U. S. DEPARTMENT OF AGRICULTURE
SOIL CONSERVATION SERVICE

INVENTORY & EVALUATION

SITUATION: Need Suitable Soil for Septic Sewage Field To Serve New Club House.

Re Proposed sewage disposal system for the Knights of Columbus Club House

KNIGHTS OF COLUMBUS

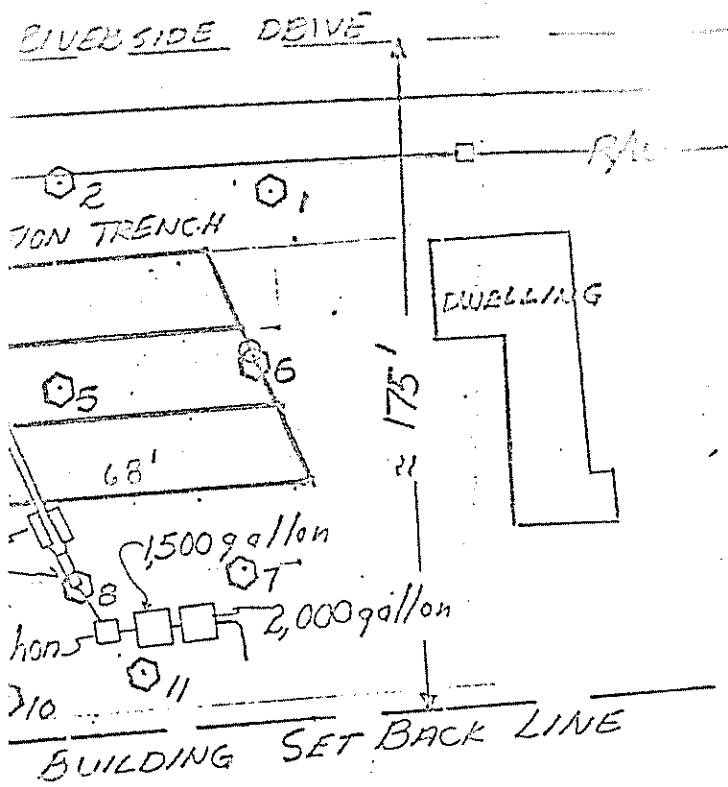
We have reviewed the soils information, percolation tests and design for the proposed sewage disposal system for the Knights of Columbus new building in Augusta. We find that the system can conform with the State Plumbing Code with or without the proposed one foot of landfill.

We are prepared to approve this installation subject to approval and permits by the Local Plumbing Inspector.
